Submission of Further Information (FI)

Temporary Shop and Services (Retail Shop for Hardware Groceries and Construction Materials) with Ancillary Facilities for a Period of 5 Years in “Residential (Group D)” Zone, Lots 681 RP (Part), 682 RP (Part) and 683 RP (Part) in D.D. 106 and Adjoining Government Land, Yuen Long, New Territories (Application No. A/YL-KTS/1102)

Further Information for Planning Application No. A/YL-KTS/1102**Response-to-Comments****Comments from Environmental Protection Department**

Plan 5.1 (P 22068B)

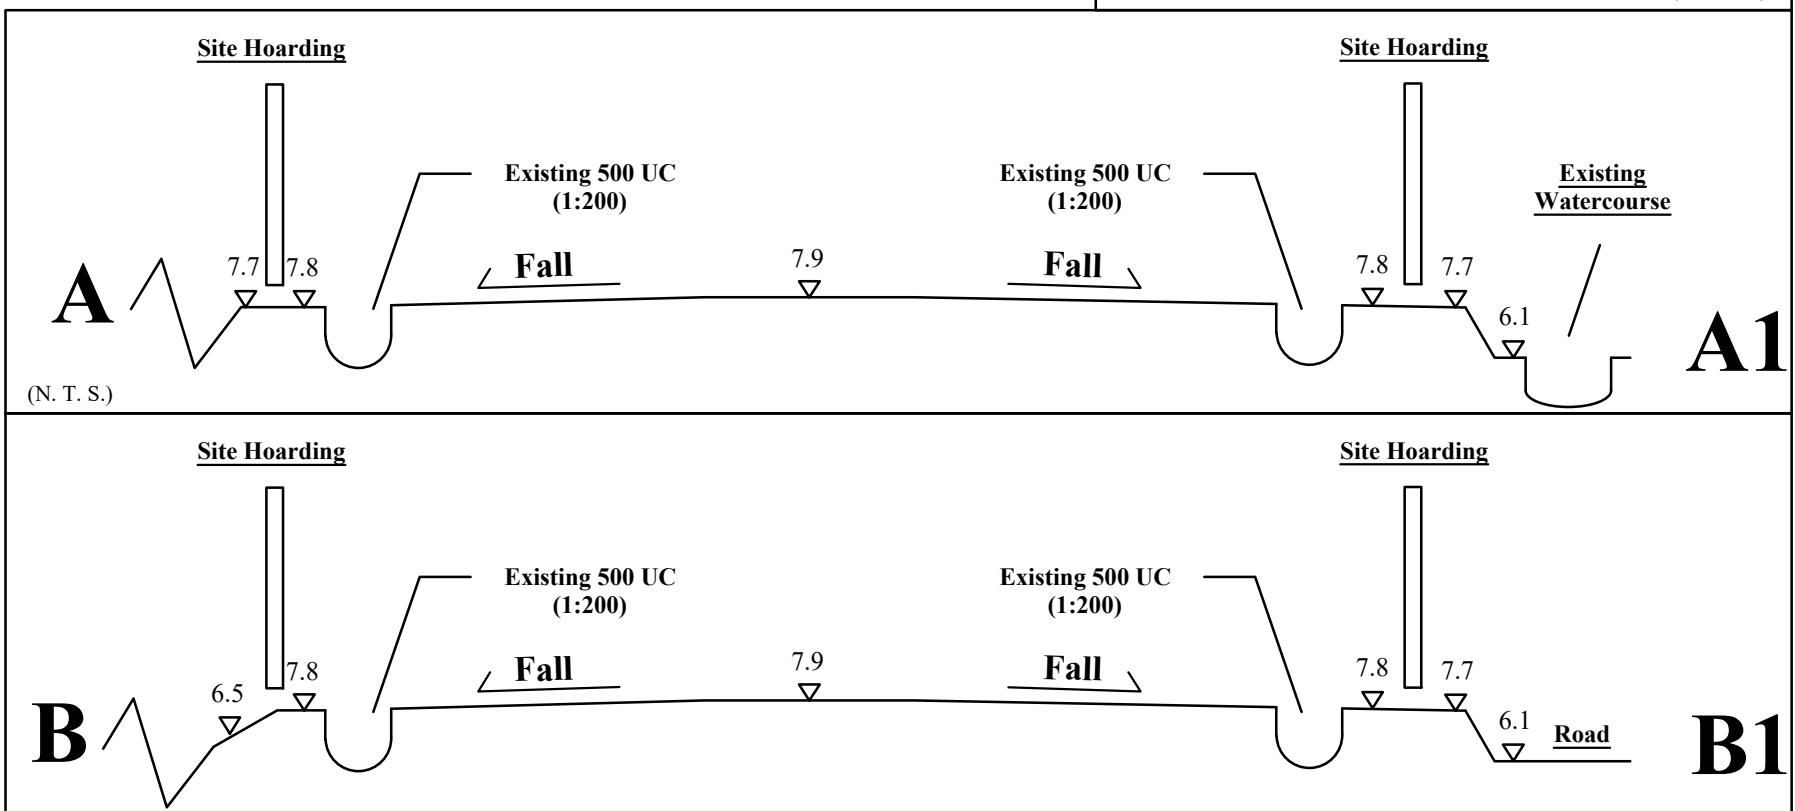
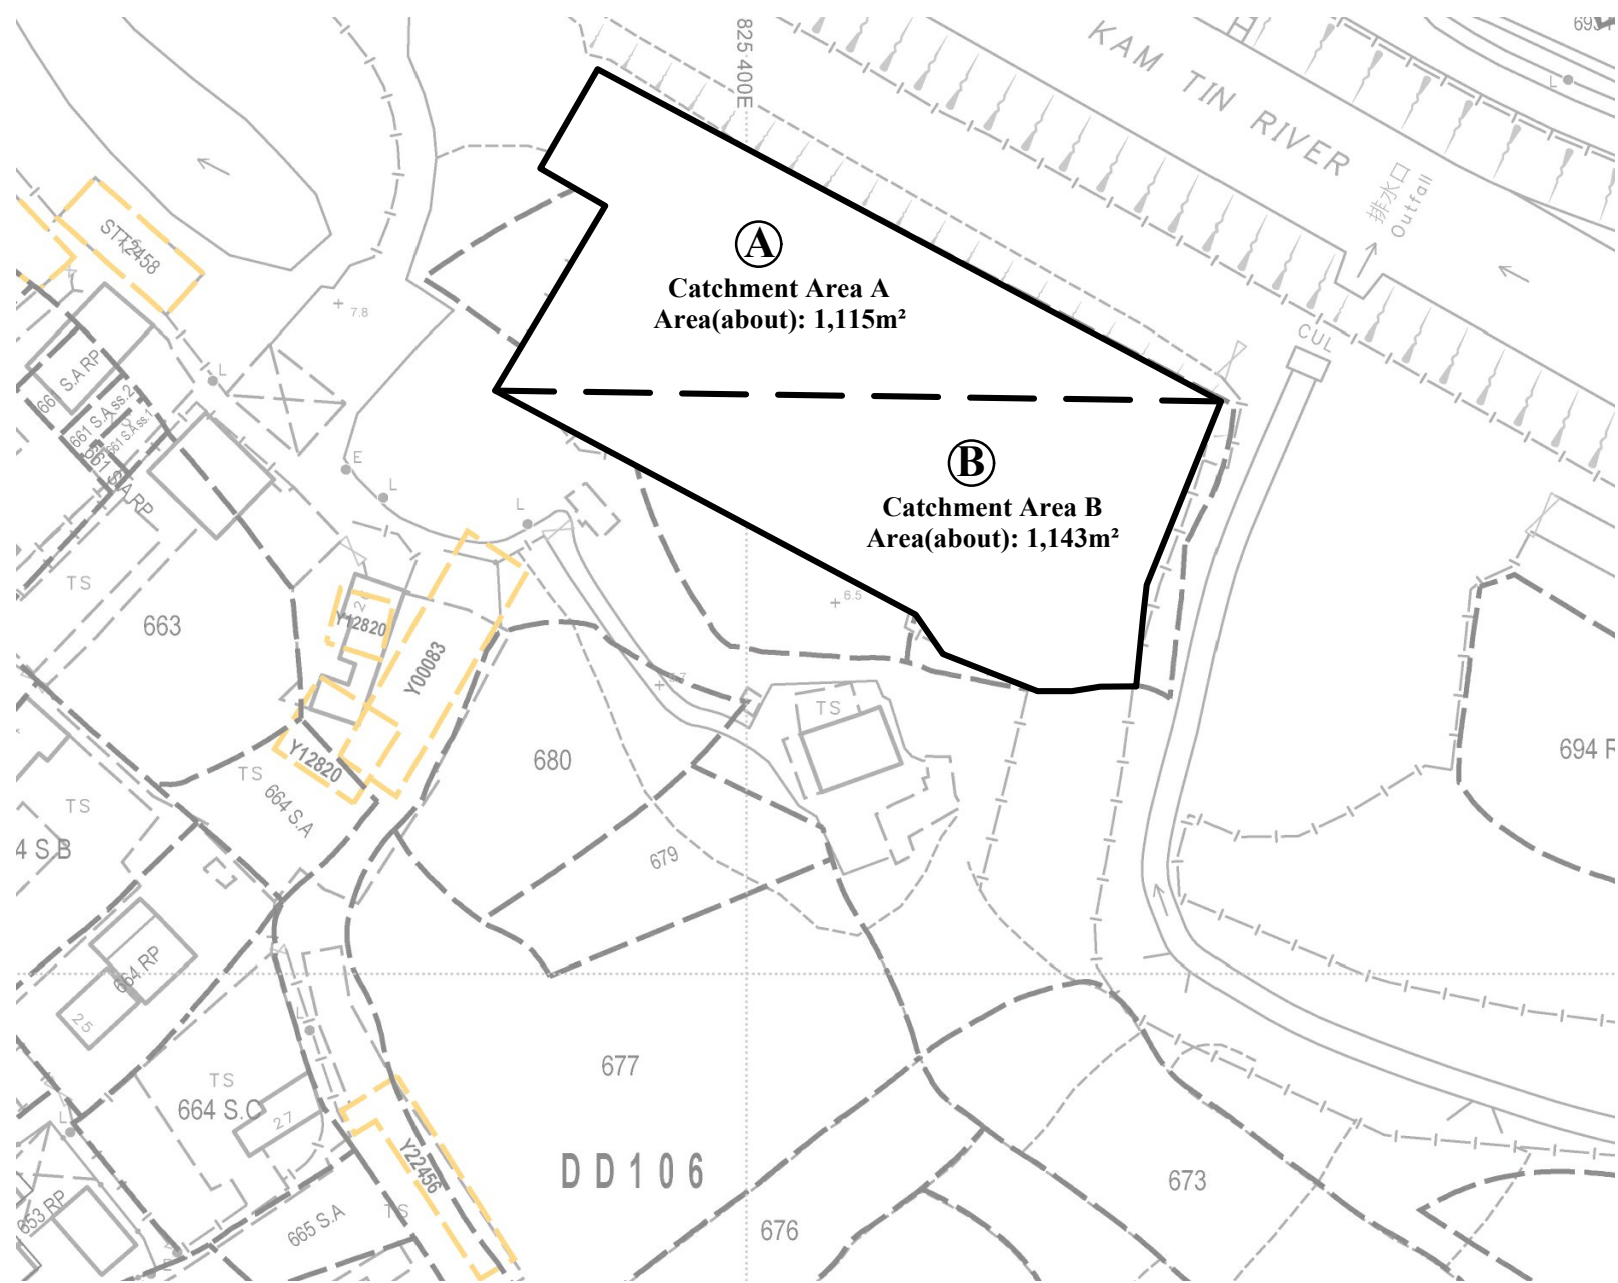
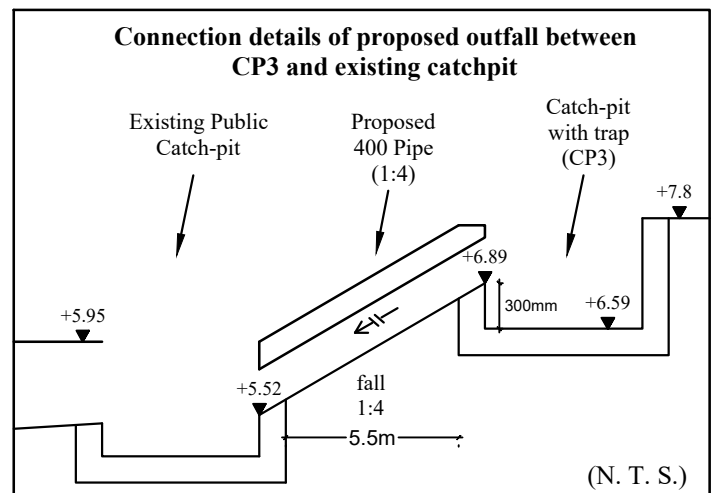
II.	Comments	Responses
1.	We are unable to provide comment on drainage aspect of the application at this stage. Comment on drainage aspect will be provided when the drainage proposal as mentioned in paragraph 26 of the planning statement is received.	Please refer to the drainage proposal (Plans 5.1 and 5.2) and hydraulic calculations for details.
